CIR Response

CIR #18

Carleton Place Arena
Renovation and Addition

CIR # 18 Detailed Summary

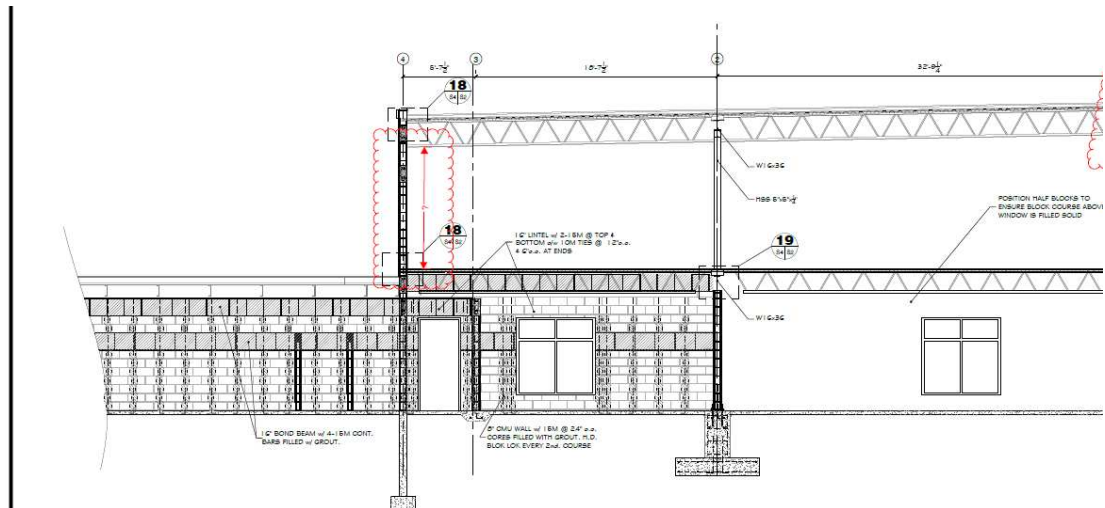
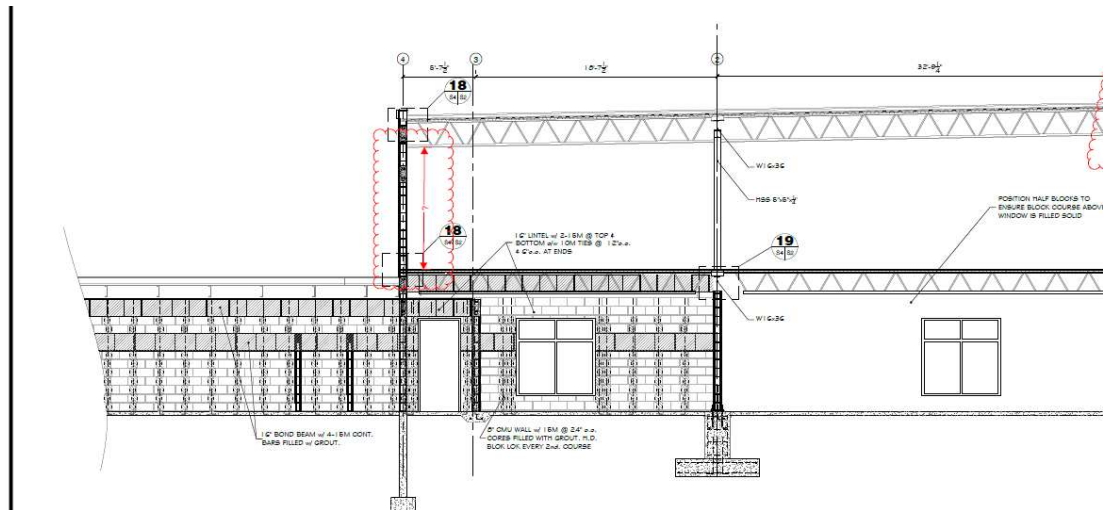
All masonry material are based in metric, and the measurement provided on the drawings does not add up to full coursing, for example: Wall Type 1, top of wall measurement is 8'8" which is the top bonding beam, this relates to 2641.6 mm. full coursing would be at 2600 mm with an added 30 mm piece that would be part of the bonding beam.

Please advise how to proceed as does not seem structurally sound.

Bonding/Lintel beams will be full blocks, filler blocks or solid grouting to be used at door/window frames as required but will not be part of bond beam. Only the use of 16" bond blocks or 8" bond block with 8" knock block will be acceptable.

Question 2, S4

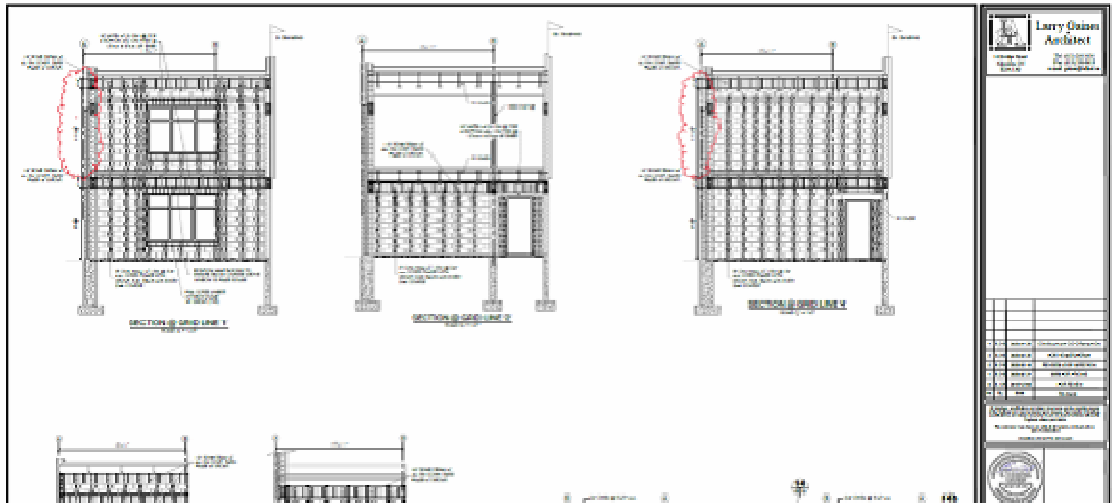
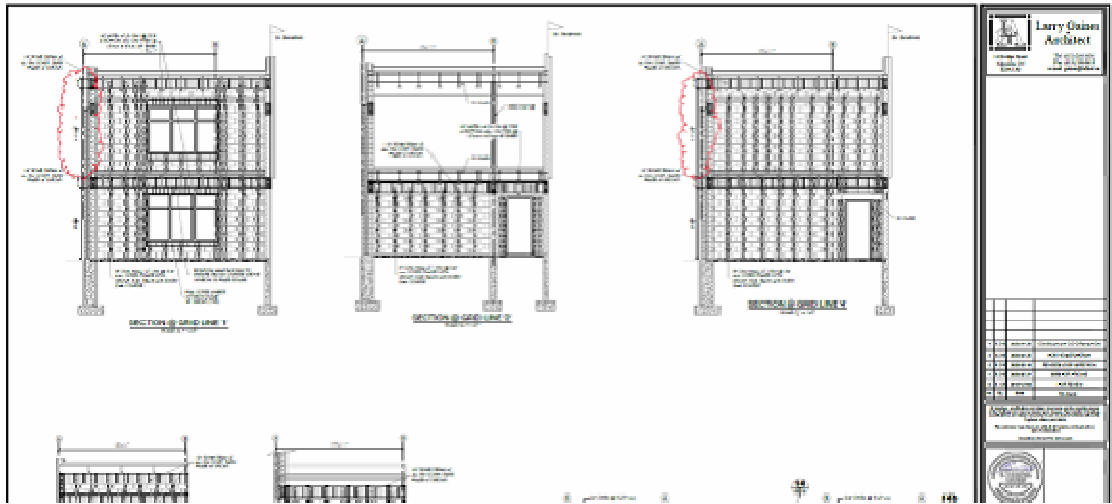
- 2. S4, provide dimension from second floor top of slab to bottom of truss at the lowest location.**

Dimension is 9'-2" +/- grouting tolerances etc.. GC should verify all dimensions with as built dimensions.

Question 3, S6

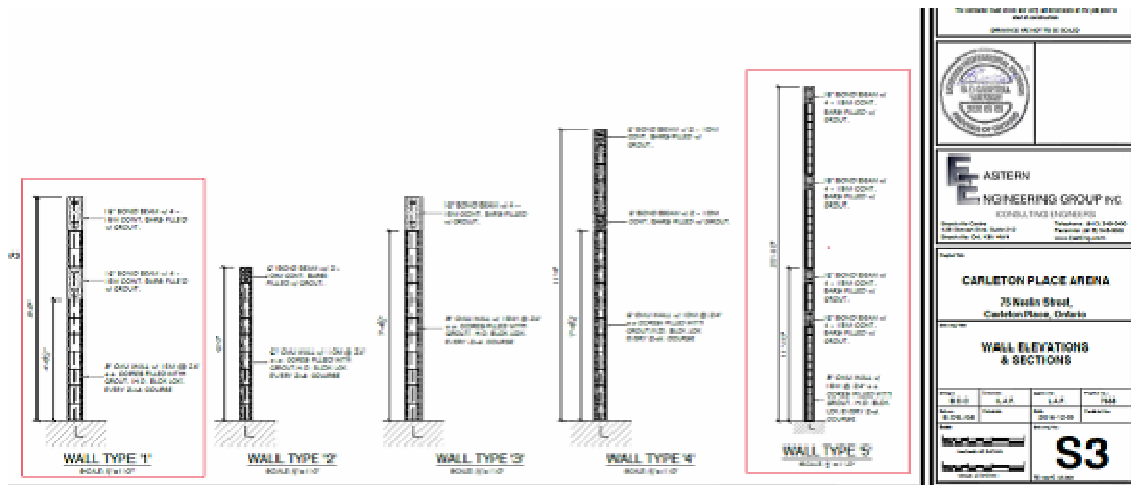
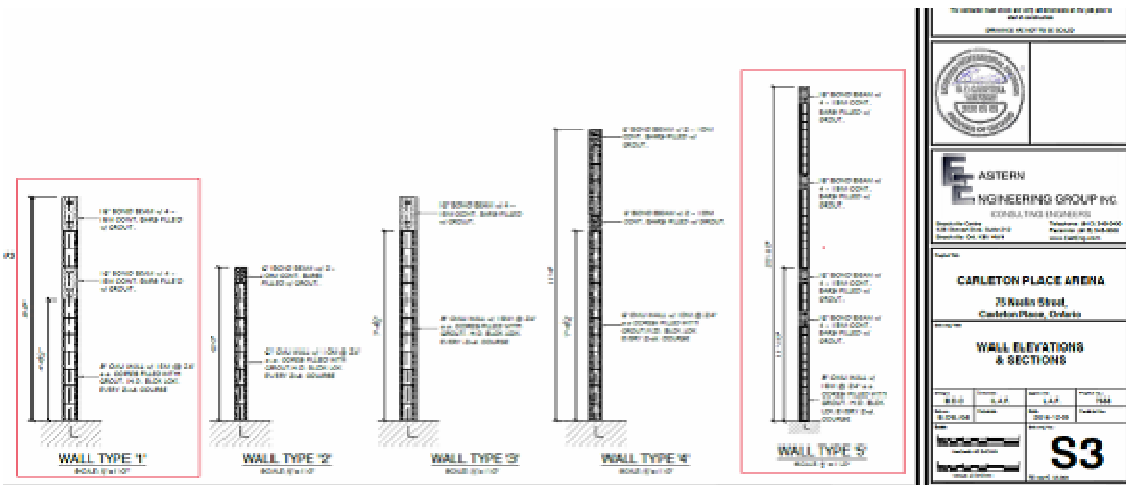
- 3. S6, Sections @ Grid line 1 and 4 fails to provide the slop required on the roof trusses, please view details below and please correct as necessary providing dimensions.**

Roof Joists were drawn at 0.25:12 slope. Please confirm with architectural required slope to scuppers

Question 4, 9, 10

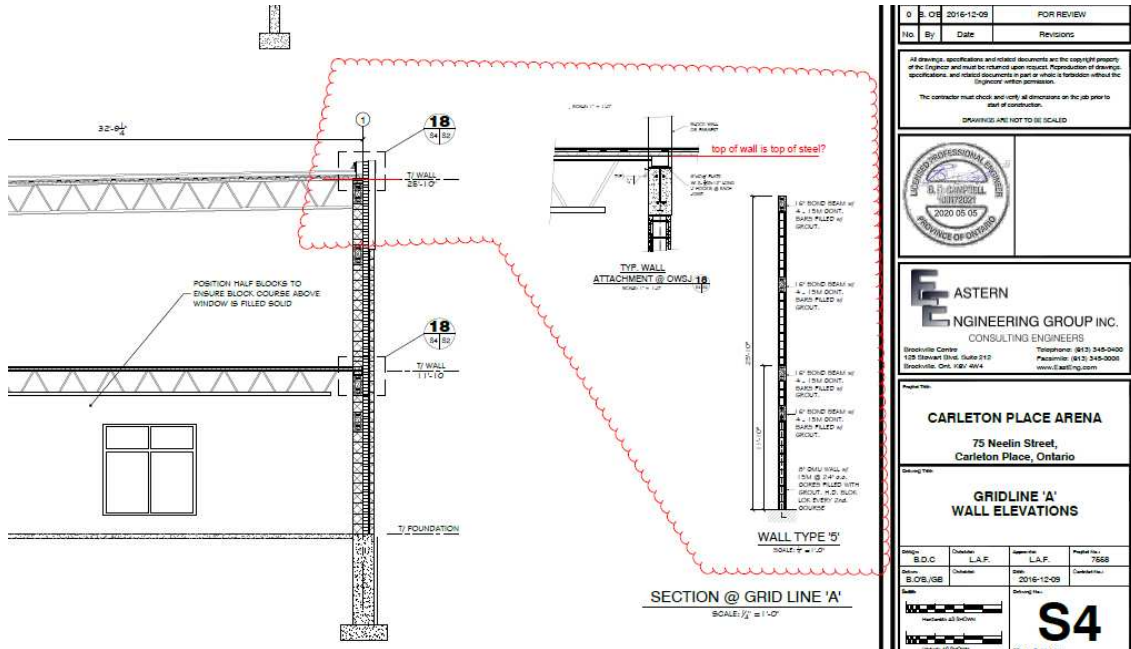
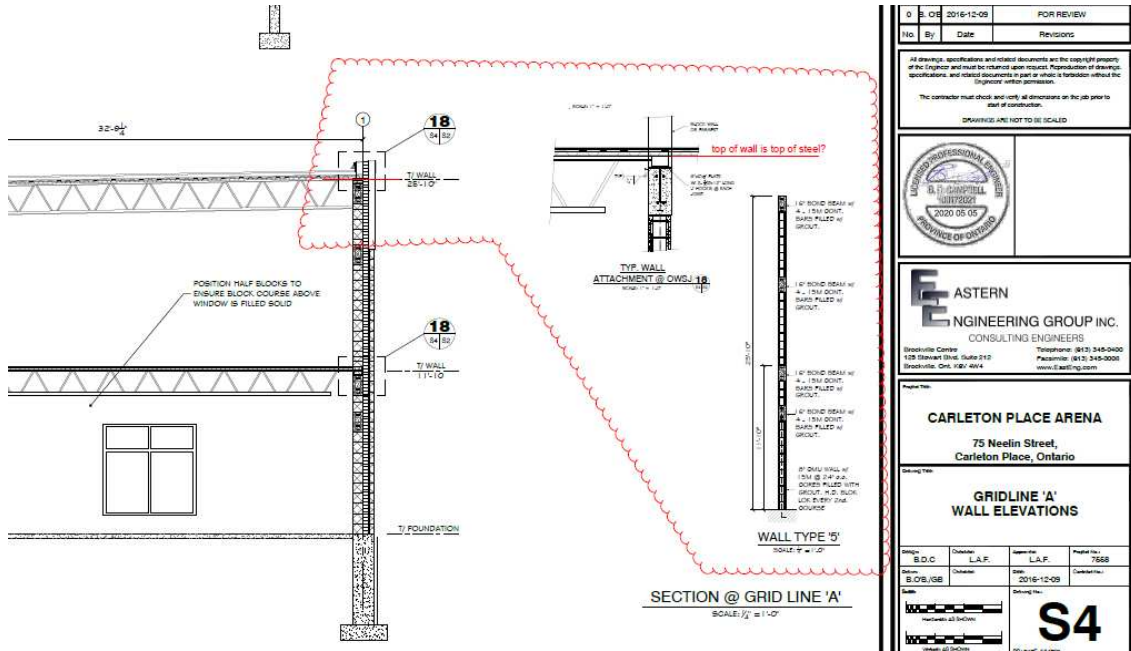
- 4. S3, Wall Types 1 -5, are these corresponding to grid line walls? If so, is Wall Type 1 assumable to be for grid line 5 and Wall Type 5 to be grid line 1?**

9. S3 provides top of wall throughout Wall type 1-5 but does not provide height of top of plate for structural steel. Please provide height from top of slab to top of plate.

10. S provides measurements for Wall types 1-5, but I do not seem to find details for wall type GL-A & B with dimensions. In addition, Drawings fail to detail a Wall Type for GL-10 as it is crucial to understand how all the components connect to finalize the wall

Wall type 1 to 5 reference walls intersecting the gird line shown. We added these references to determine where bond beams would intersect etc... They do not correspond to gridline walls.

Please confirm this question is valid. Height to top of slab to top of steel plate is the wall height + plate thickness.

All wall types described above are wall type 1 as noted on drawings. Sections of GL A and GL B on S3/S4 provide wall heights-however does not address the fact the floor slopes throughout the building and was measured for a relative position of the section. GL-10 height will vary with the profile of the roof. It should be noted that block wall will extend past this with compressible gasket per details on S2. Refer to Arch. for dimensions.

Question 5

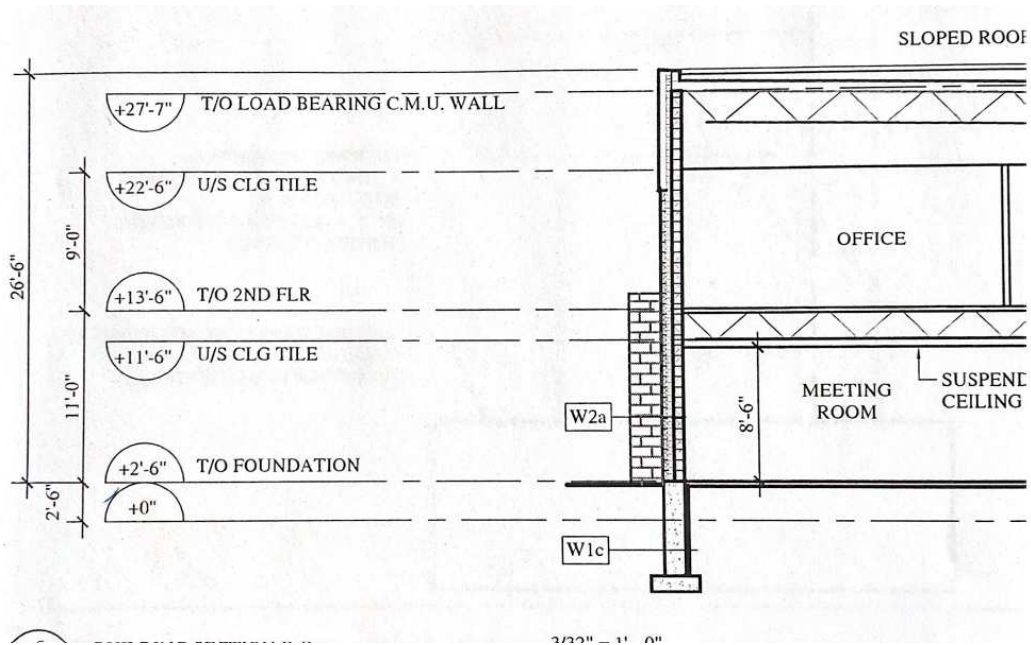
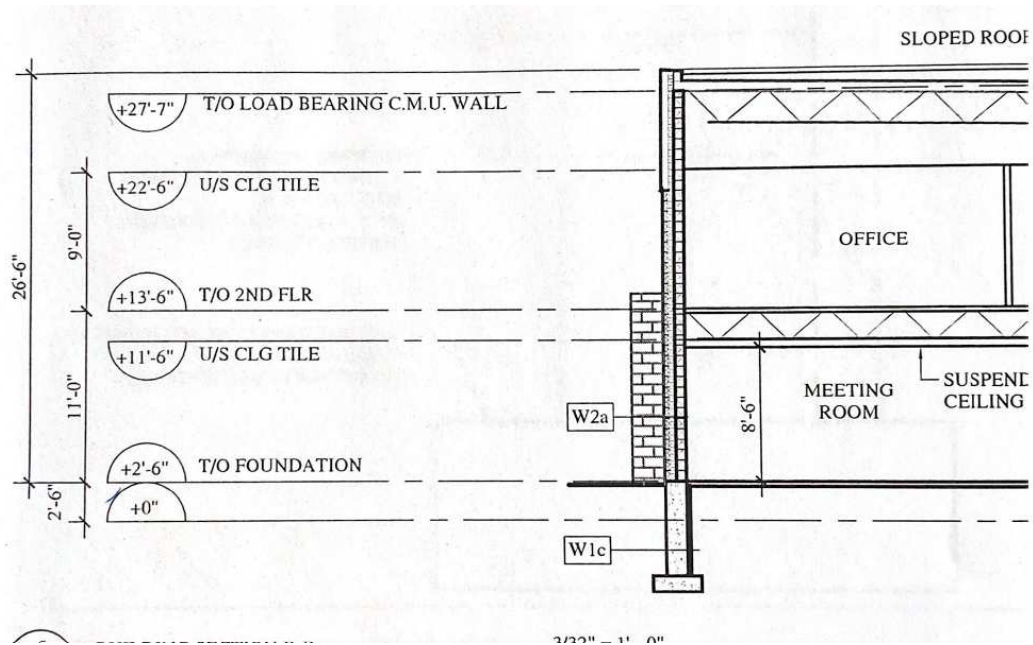
5. S3/S4, assume that Wall Type 5 pertains to GL 1, this wall has a measurement of 25'10" top of wall and at Section @ Grid Line A & B detail shows to have same dimension but seems to be top of truss.

True, error shown on drawings dimensions go to Top/ Truss. Adjust wall height to suit truss show depth.

Question 6, 5/A6

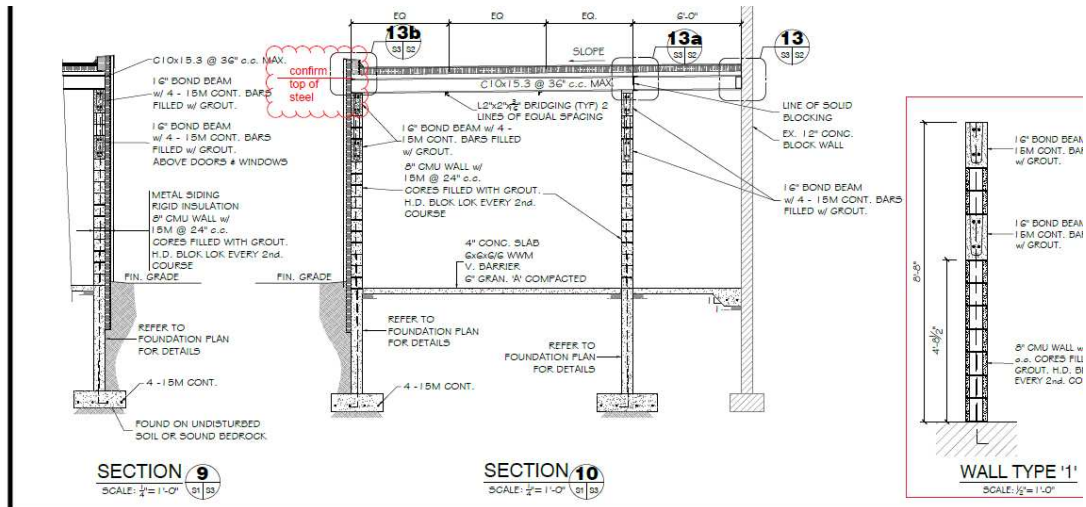
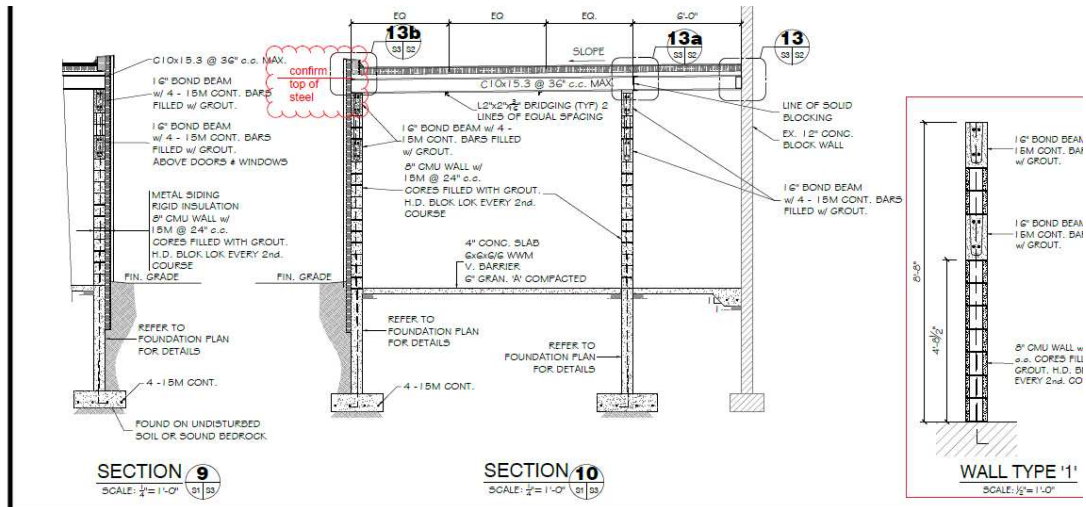
6. Comparing as labeled, Wall Type 5 for grid line 1 with measurement of 25'10" and 4/A6 with elevations provided top of wall, calculations add up to 25'. What is accurate dimension/elevation of top of wall.?

Architectural shall govern, see item addressed in Q5 for possible discrepancy.

Question 7, S4/Section 10

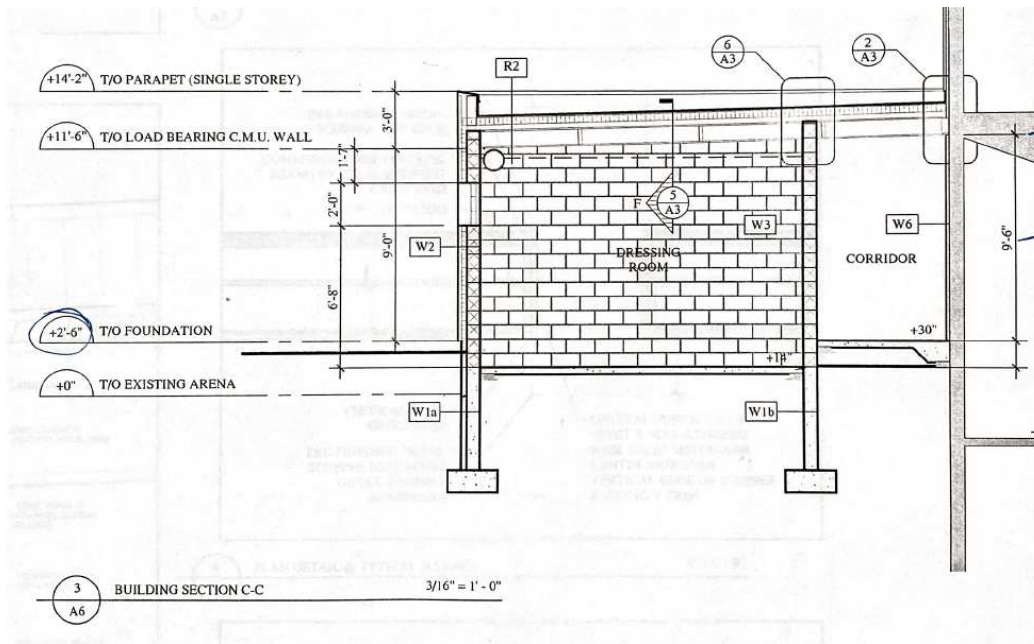
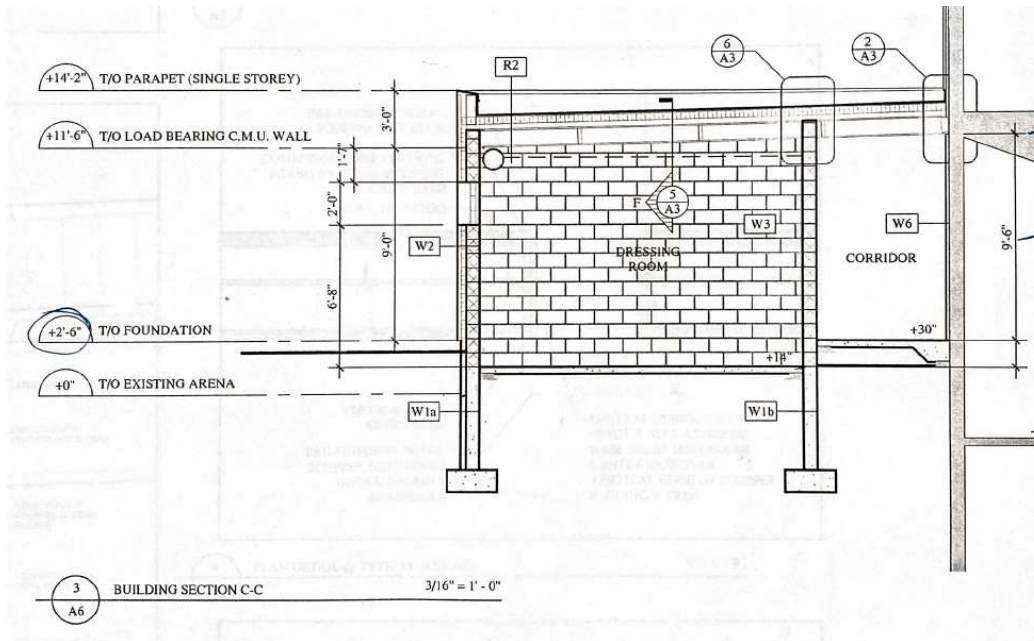
7. S4/Section 10, What is the dimension from top of slab to top of steel?

Please confirm you mean section @ Grid A. Top floor slab to U/S steel on which level?
